FINAL ENVIRONMENTAL IMPACT STATEMENT

SOMERS CROSSING

Date: **APRIL 7, 2016**

FINAL ENVIRONMENTAL IMPACT STATEMENT

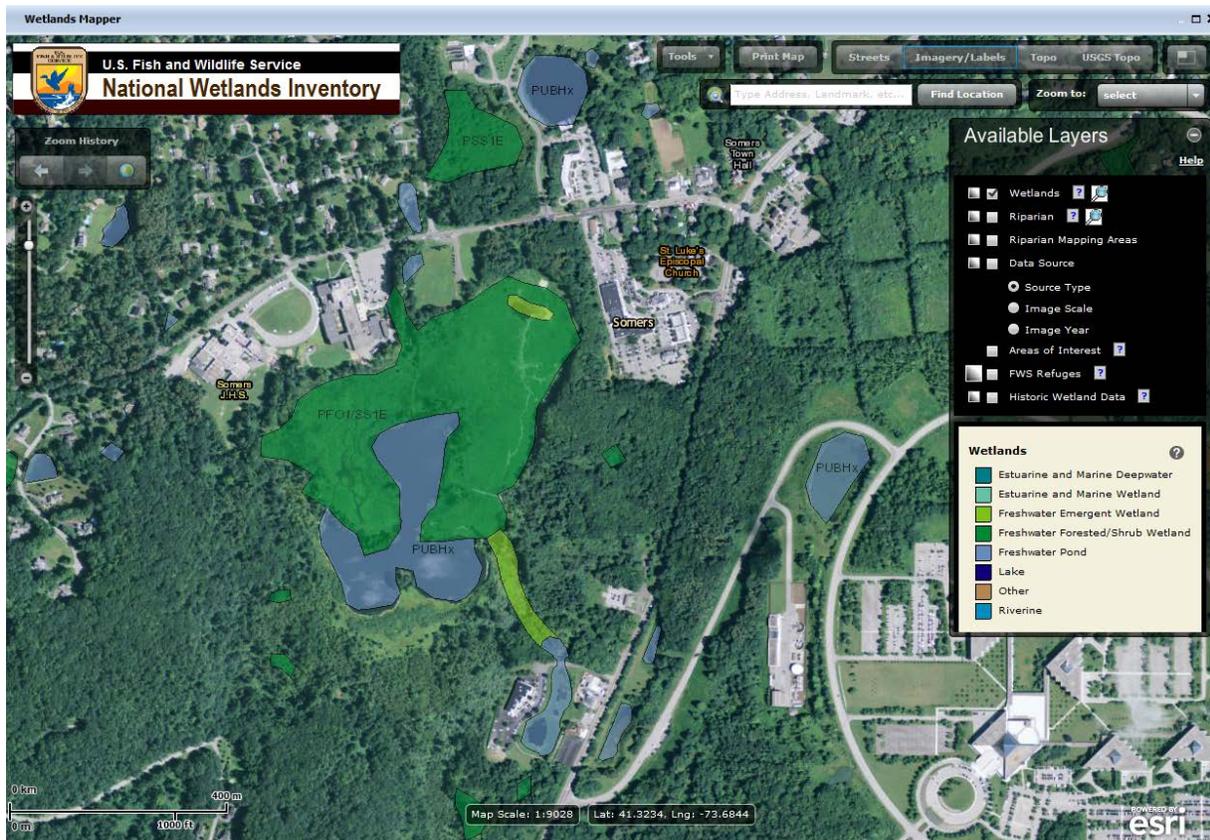
The Applicant shall provide more detail to describe the location, hydro-geomorphic classification, soils, vegetation and hydrology of the identified off-site wetland areas.

(Letter #7, Woodard & Curran, 3/24/15)

Response F21:

The off-site wetland is located to the west of the on-site portion of wetland. Both on and off-site wetlands (with the exception of the existing stormwater basin) are part of DEC Freshwater Wetland F-1 which is, in total, 194.6 acres in size (reference: NYSDEC Resource Mapper, accessed online). Of the 194.6 acres, approximately 46 acres are located immediately off-site to the west of the property (reference: Wetlands Mapper on US Fish & Wildlife Service website), adjacent to the 5.07 acres of on-site wetland. The hydrogeomorphic classification of the off-site portion of wetland nearest Brown Brook is riverine. This portion is associated with the brook and is sustained by runoff and groundwater. Closer to the uplands, the off-site wetlands are considered slope wetlands (as is the on-site portion of the wetland). Slope wetlands are sustained mainly by groundwater.
